Proposal #13: 5681-00-73, WISC 2026134
T Mifflin – T Linden (CTH E)
E Pecatonica River Bridge B-25-0199
CTH E
Iowa County

This is Addendum No. 01, which provides for the following:

ADDENDUM NO. 01

Addendum No. 01
ID 5681-00-73
Revised Sheet 66
January 5, 2026

GENERAL PLAN

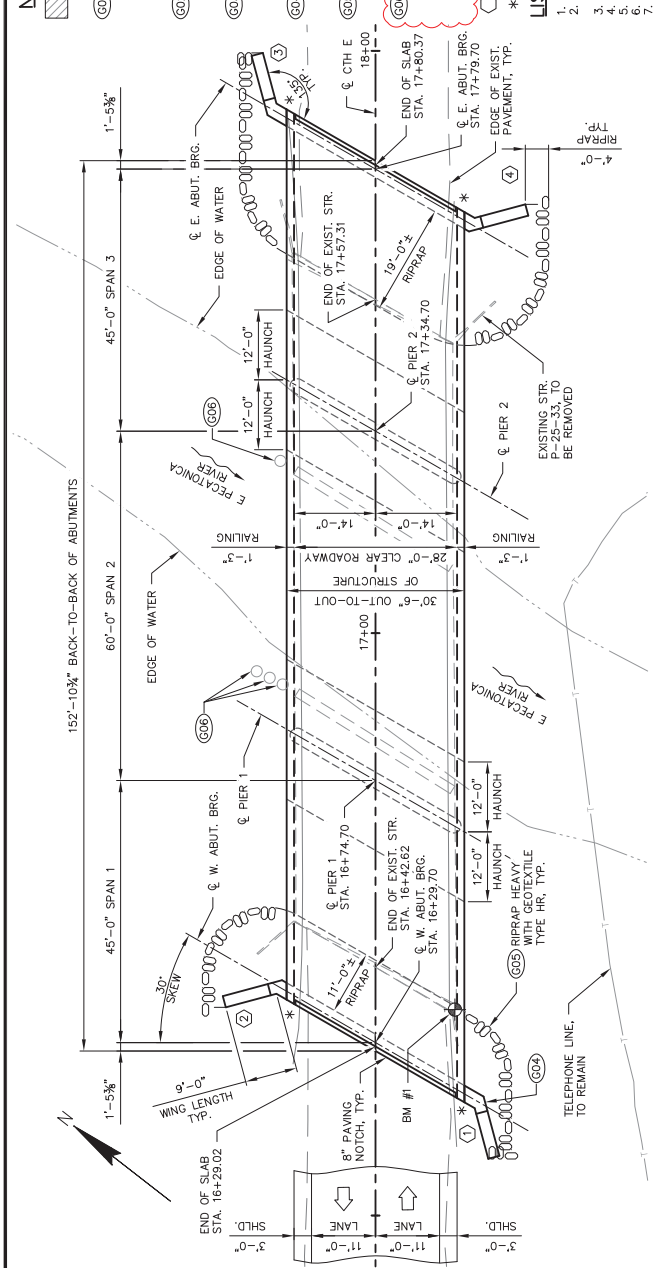
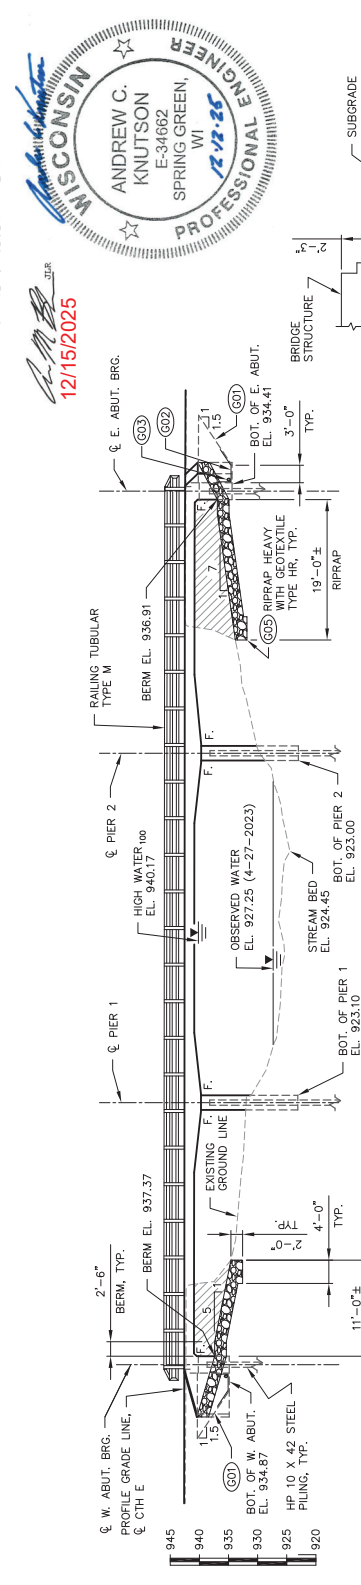
Revised Plan Sheets	
Plan Sheet	Plan Sheet Title (brief description of changes to sheet)
66	Structure General Plan – Replaced “Removing Structure Over Waterway Minimal Debris” with “Removing Structure Over Waterway Debris Capture” in notes.
67	Structure Cross Section, General Notes, & Quantities – Replaced “Removing Structure Over Waterway Minimal Debris” with “Removing Structure Over Waterway Debris Capture” in notes and the quantities table.

EXISTING TIMBER PILES NEAR EXISTING PIER 1 & EXISTING PIER 2 SHALL BE REMOVED. COSTS ASSOCIATED WITH THE REMOVAL OF THE EXISTING TIMBER PILES SHALL BE INCLUDED IN BID ITEM CAPTURE P-25-33.
